Heritage Impact Assessment Addendum

Brampton Memorial Arena Expansion

69 Elliot Street

May 10, 2024

Figure 2: Revised floor plan with one central public entrance and two program blocks. The public program is located in a higher volume block offset from the heritage arena while the lower volume service space block minimizes impact on the arena wall and roof.

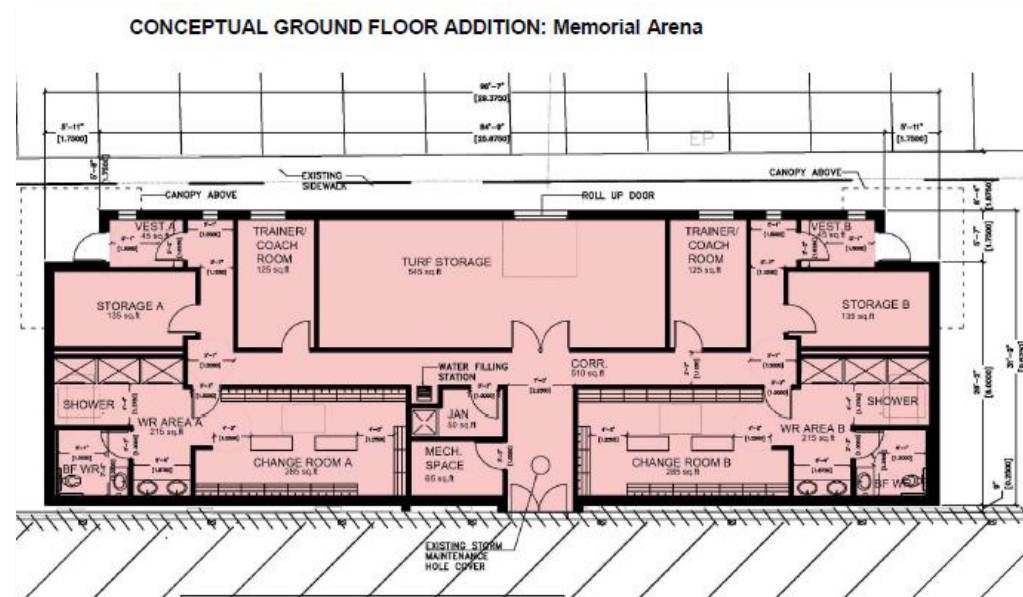
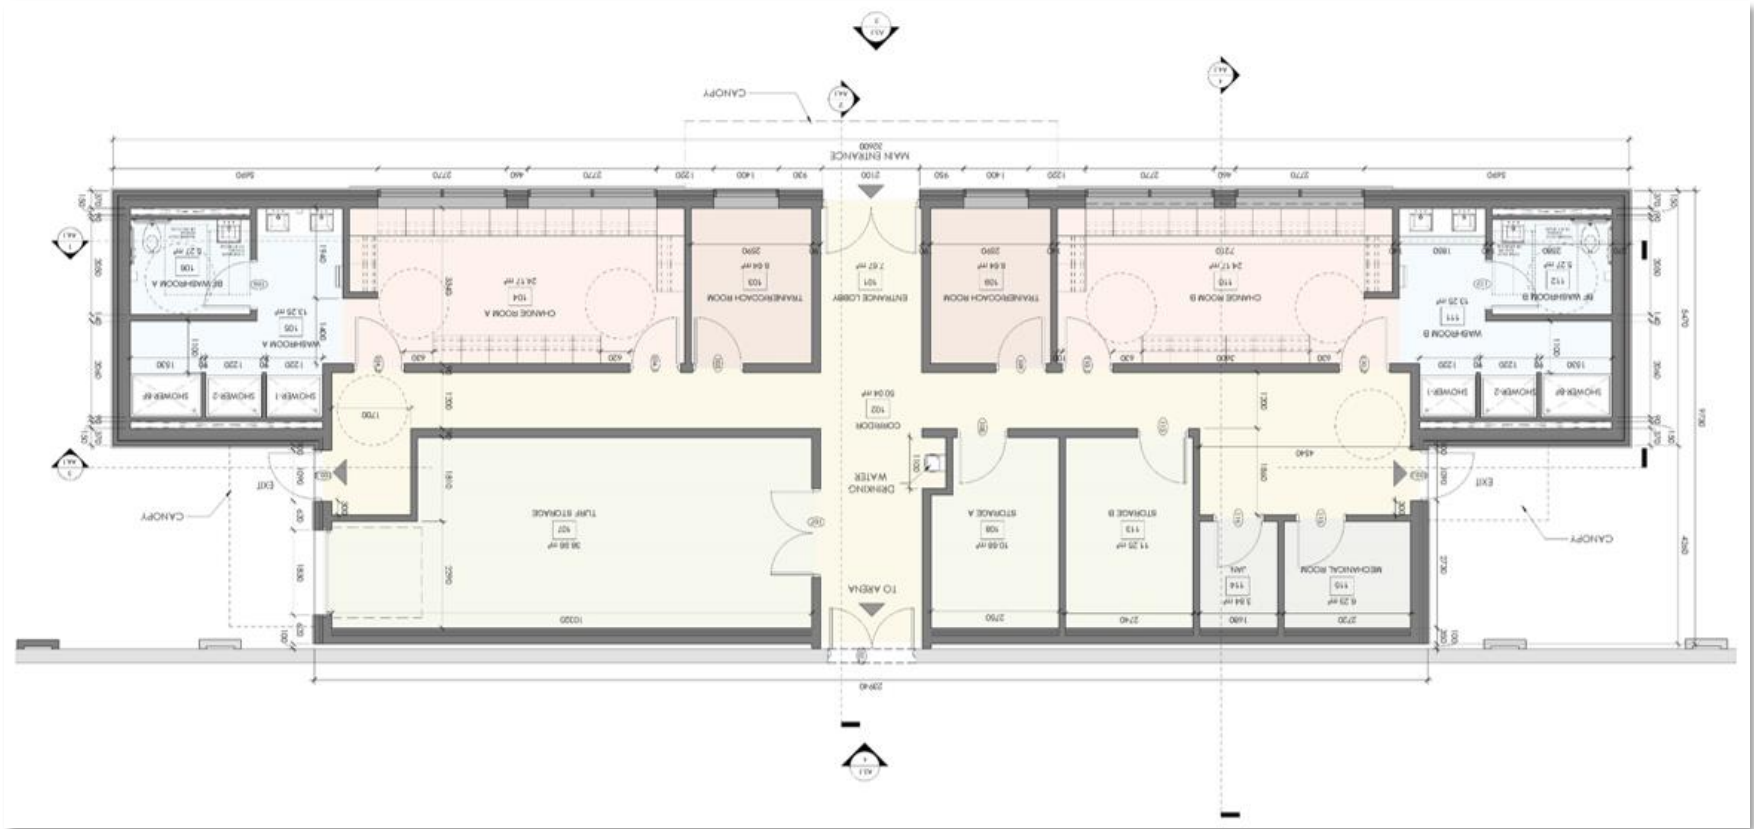
A subsequent version of the program dated December 2022 revised the program for the addition to replace a proposed boardroom with a Turf Storage space. The Turf Storage in the updated design effectively replaced the boardroom in the centre of the addition with a proposed roll-up door for forklift access in a prominent location on the main facade of the addition.

To minimize the impact of the new turf storage program on the main façade of the addition, +VG Architects proposed a reorganization of the addition with:

- one central public entrance,
- shifting the change rooms and office program spaces to the main façade and
- demoting the turf storage and other storage and service spaces to a lower block of space immediately adjacent to the heritage arena.

These organizational adjustments provided some significant benefits to the proposed addition and its impact on the heritage arena. By organizing the ‘public’ spaces of the addition in a higher volume block permitted these public spaces to have access to windows and natural light. The service spaces were organized within a lower volume block that is set in from the overall width of the addition. The creation of two volumes enables the lower volume to tuck beneath the eave of the iconic Hipel roof of the arena and effectively creates a ‘reveal’ between the new higher volume and the heritage arena.

This lower roof also provides a well-hidden location for the rooftop equipment required to serve the new addition without any additional screening required.

1.4 Material Palette

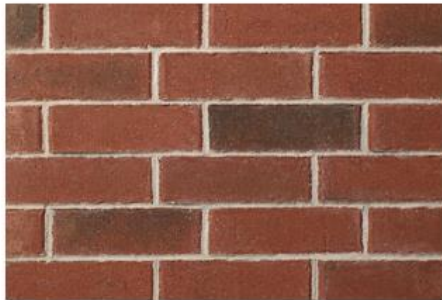
OPTIONS TO BE CONSIDERED	CURRENT DESIGN MITIGATION MEASURES
<i>A change in material to a lighter structure and cladding above the fascia line of the existing Hipel roof in the new addition (all three sides).</i>	The current design proposes to transition from brick to an aluminum plate cladding above the fascia line of the Hipel roof of the arena
<i>The introduction of a sloped roof above the fascia line of the Hipel roof in the new addition.</i>	Not necessary as the relationship between the roof of the addition and the arena has been simplified.
<i>A change in materials/construction only at the triangular junction points is not recommended. It would appear visually as a mistake or afterthought.</i>	Not applicable – triangular junction points have been eliminated.
<i>Additional articulation of the addition wall to increase compatibility and human scale.</i>	The addition has been articulated with a variety of techniques including roof scupper ‘reveals’, vertical control joints in the brick cladding, a continuous stone sill course aligning with the continuous sill on the north pavilion.
